IEEE802.3 4P Task Force
Channel Pair To Pair Resistance Imbalance
(End to End System Imbalance)
Ad Hoc
July 14, 2014

Meeting #11: Rev 015, Tuesday August 12, 2014

Yair Darshan
Microsemi
ydarshan@microsemi.com

Figure 1. May 27, 2014

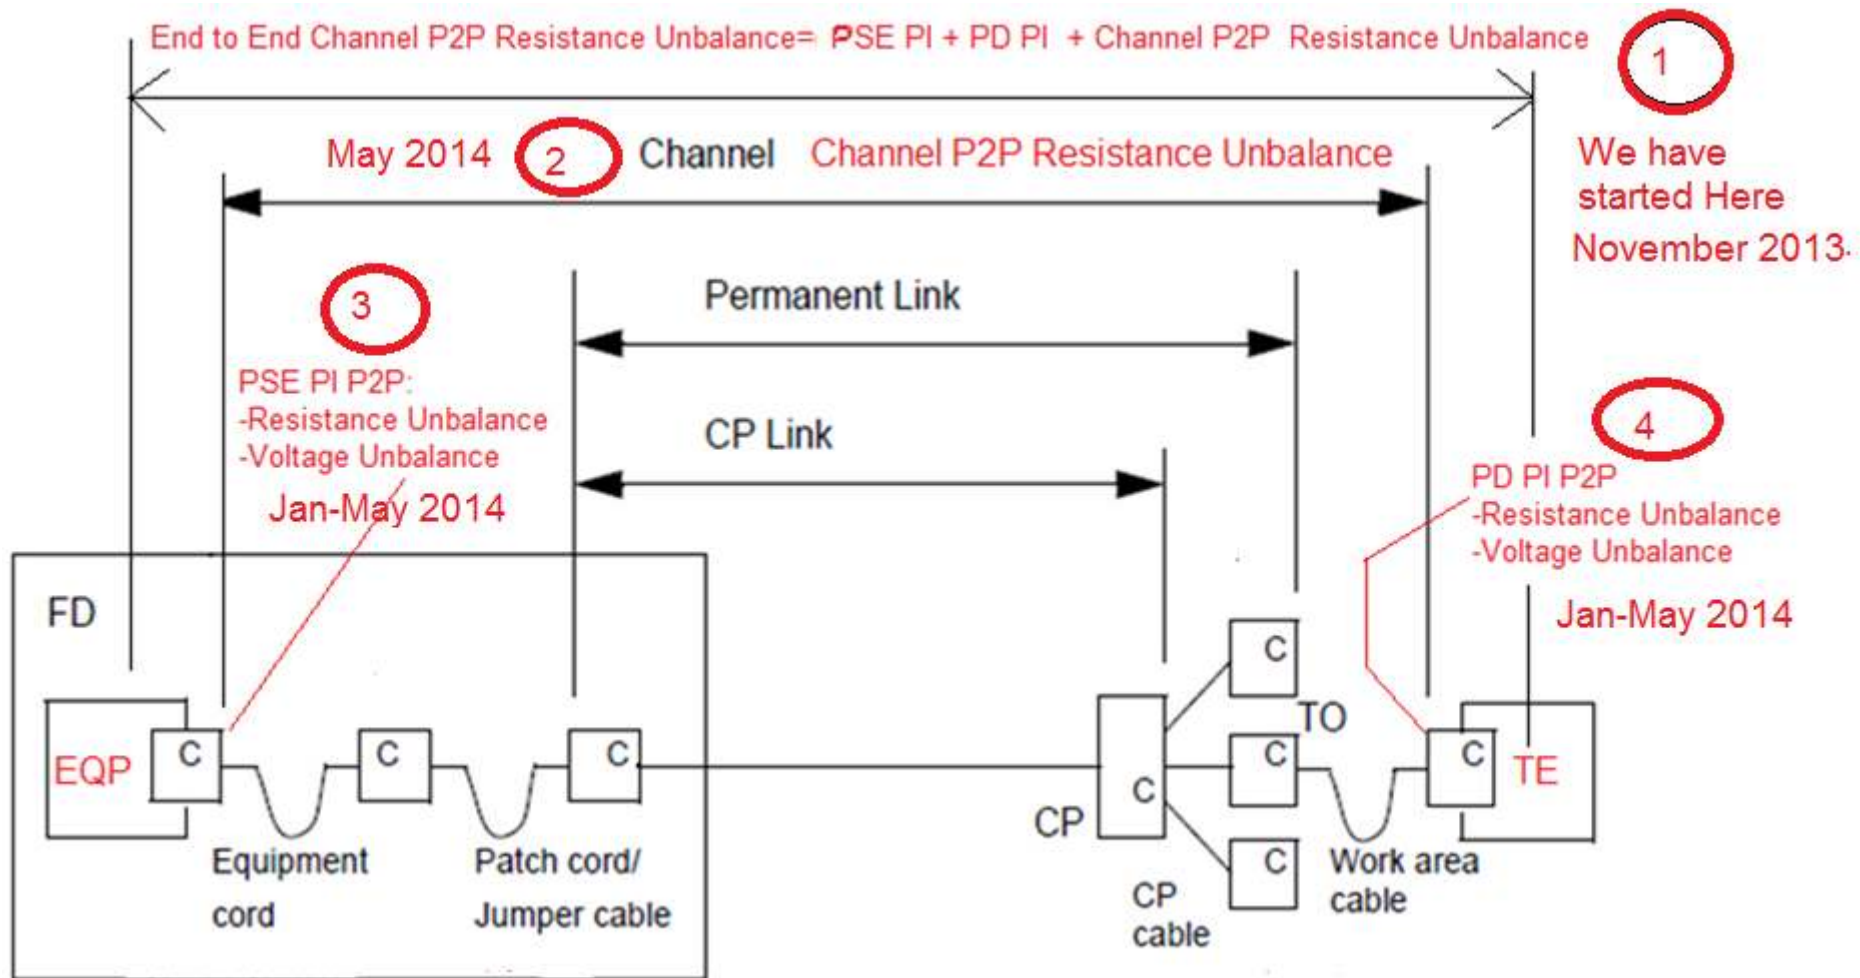
Ad-hoc response, July 16, 2014. No comments.
